**NUMBER:** 16-001-13**GROUP:** Prop Shaft / U-joint**DATE:** January 17, 2013

Driveline Vibration

2012 DP Ram 4500/5500 Cab Chassis

Fig. 1 Drive Shaft Center Support Bearing Bracket

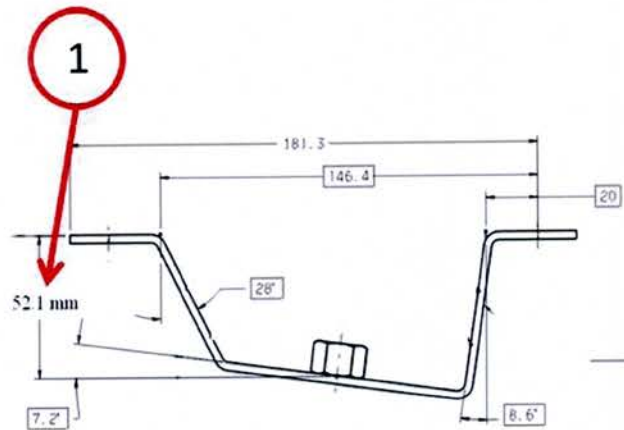
A small number of vehicles were built with an incorrect drive shaft center support bearing bracket. The bracket on these vehicles may have an incorrect height which could allow the drive shaft to operate at an angle that could cause the driveline to vibrate while the vehicle is in motion.

2. Measure the height of the drive shaft center support bearing bracket from the attaching fastener to the frame rail (Fig. 1). The distance should be 52.1 mm (2 inches). Incorrect drive shaft center support bearing brackets will be 82 mm (3.25 inches).

8. Install new drive shaft center support bearing bracket (p/n 52123065AB) securing it with the attaching fasteners. Tighten the bolts to 54 N·m (40 ft. lbs.).
